Date		08.02.2010	
Created by		Shen Pp	
Checked		Yang Yue	
Standard		Standard	
Replacement for		Replacement for	
Origin		Origin	
Replaced by		Replaced by	
HVAC-System		HVAC-System	
Amsterdam		Amsterdam	
Saloon wiring diagram		Saloon wiring diagram	
KS97A900.000-00A.S4		KS97A900.000-00A.S4	
Sheet 1		Sheet 1	
9 Sh.		9 Sh.

Date	08.02.2010	Replaced for	3	4	5	6	7	8	9	+
Created by	Shen Pp	Replaced by								
Checked	Yang Yue	Standard								
R Change	11.04.2014	Name								
R		Origin								
HVAC-System Amsterdam Saloon wiring diagram KS97A900.000-00A.S4 Sheet 4 9 Sh.

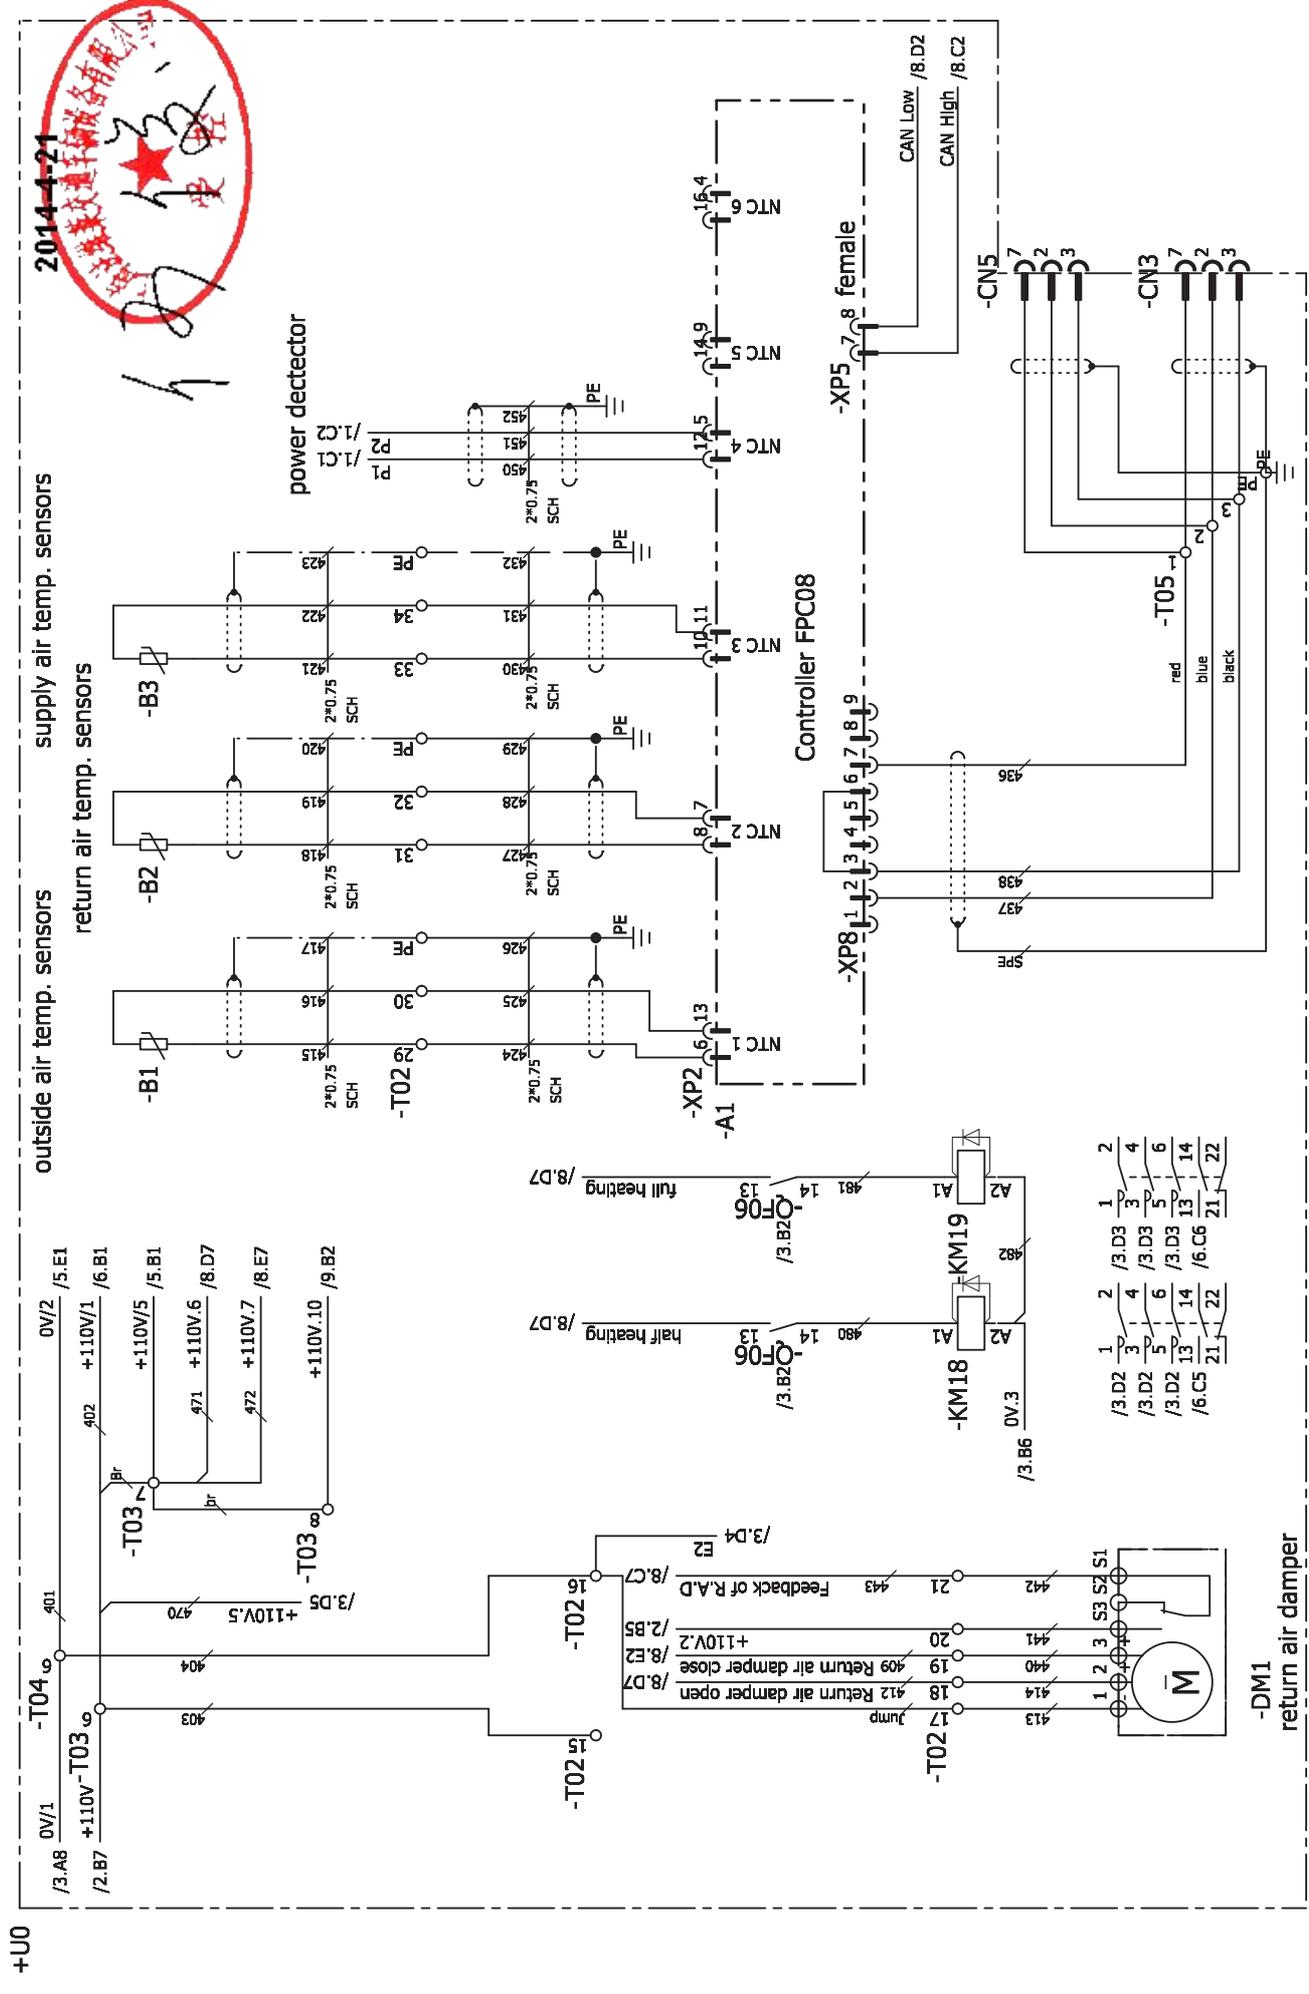
18.12.12	Version Q	Add set point of motor starters , thermostat relays and thermostat controller	P1,P3
11.04.14	Version R	Change connection of Thermostat controller	P3
